Serial No. 06-273
ESP/JDH
Docket No. 52-008

DOMINION NUCLEAR NORTH ANNA, LLC
NORTH ANNA EARLY SITE PERMIT APPLICATION
RESPONSE TO NRC QUESTIONS AND REVISION 6 TO THE NORTH ANNA ESP APPLICATION

Enclosure 1
Dominion Response to March 2 and
March 13, 2006 NRC Questions

NORTH ANNA UNIT 3 CLOSED CYCLE CIRCULATING WATER SYSTEM DIAGRAM

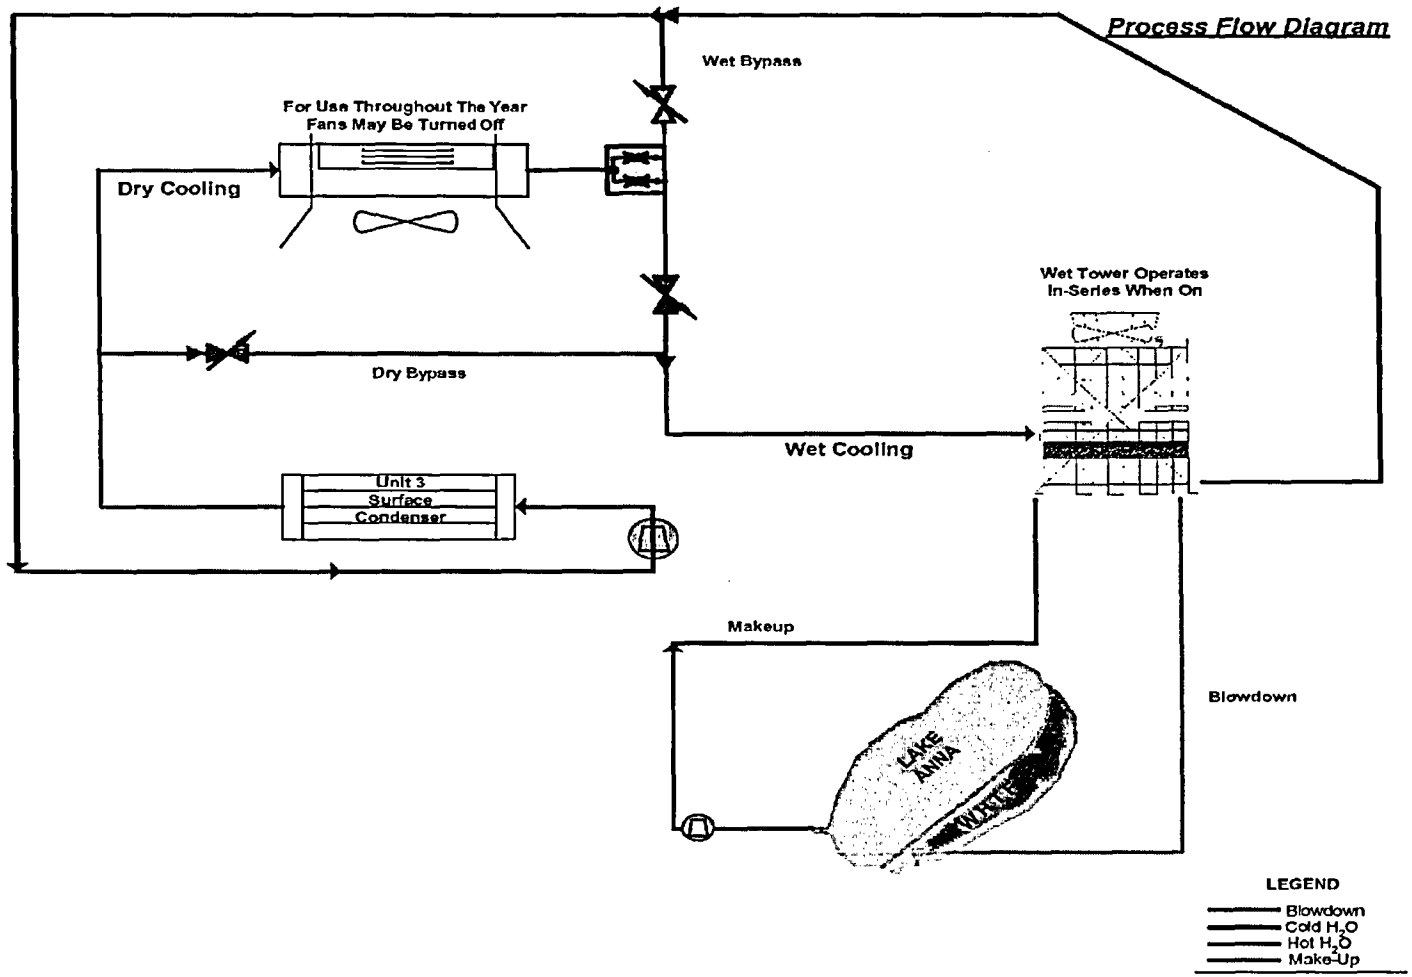
m. **With respect to SSAR Section 2.4, the ESP application supplement changed the normal plant cooling system for proposed Unit 3 from a once-through system to a wet and dry hybrid cooling tower system.**

(1) **Provide a conceptual description of the hybrid cooling tower system, its interaction with safety-related components, and an assessment of the reliability of this system.**

(2) **Describe how the hybrid cooling towers function for the normal cooling system (NCS) for the plant, and whether or not the NCS draws water from the ultimate heat sink (UHS) underground reservoir. If so, show how the remaining volume of water in the UHS reservoir will be adequate for a 30 day cooling water supply for safety system cooling.**

The normal plant cooling system is a closed cycle system combining dry and wet cooling towers to provide the capability to reduce water consumption during drought conditions. The process flow diagram for the system is shown in the attached Figure. In the Maximum Water Conservation (MWC) mode of operation, heated cooling water leaving the plant main condenser would be cooled in a dry cooling tower section where a minimum of one-third of the heat would be rejected. The cooling water passes through the tubes of the dry cooler while fans move air across the outside of the tubes to transfer the heat to the air. After passing though the dry coolers, the water then passes through a wet cooling tower section, where the remaining heat is dissipated by spraying the water into an air stream, achieving the majority of the heat transfer by evaporation of a portion of the water. The cooled water then returns to the plant condenser to condense the steam leaving the turbines. When the system is in the Energy Conservation (EC) mode of operation, the dry tower fans are turned off with 100% of the cooling then provided using the wet tower section.

ER Section 3.4.1.1 is revised to include the diagram of the cooling system shown in the attached Figure and to describe examples of the water saving features that could be used in the wet towers. The figure in the ER Section also includes a plant service water system described in the section.

Figure 1: Flow Reduction ($\Delta Q = Q_2 - Q_3$) over Dam (from October 1978 to April 2003)

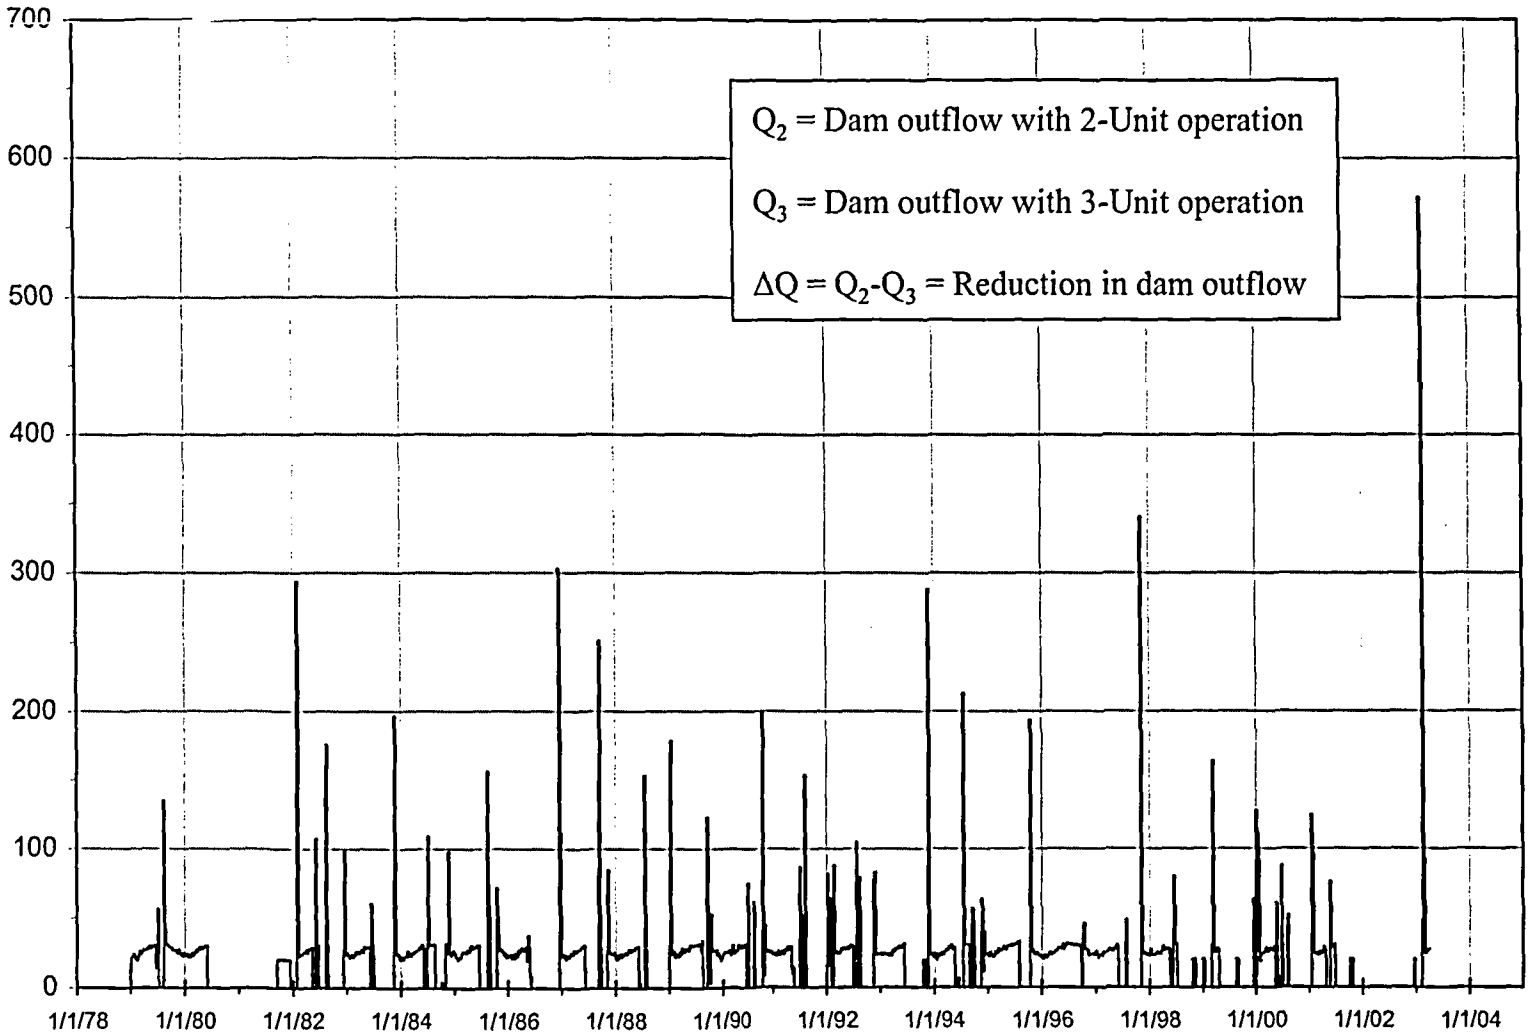
a. **Section 5.2.2.2 states that the frequency of reduced flow from the dam would increase. Provide an analysis of the impact on fish and other aquatic communities in the North Anna River downstream of the dam. Specifically, address how the reduced water flow rates would affect environmental conditions at known striped bass spawning habitat areas during the striped bass spawning season.**

Certain characteristics of the changes in flow at the dam between 2-unit and 3-unit operation are apparent from these calculations as illustrated in Figure 1:

- There are short periods with a difference of 20 cfs, e.g., when 2-unit operation is releasing 40 cfs minimum flow, but 3-unit operation, with a lower lake level, would release 20 cfs, which would have occurred seven times in the 1978-to-2003 period, lasting one week to 3 months;

- There are periods when the 2-unit dam release is much larger (up to 550 cfs, but mostly 100 to 350 cfs) than the 3-unit release, due to the fact that runoff after a dry period fills the reservoir level to elevation 250 ft more rapidly for the 2-unit case and nearly all the river inflow is passed over the dam for a short period before the reservoir would have filled under the 3-unit scenario. Flow differences above 100 cfs would have occurred approximately 25 times in the 1978-to-2003 period, with each episode lasting a few days to two weeks.
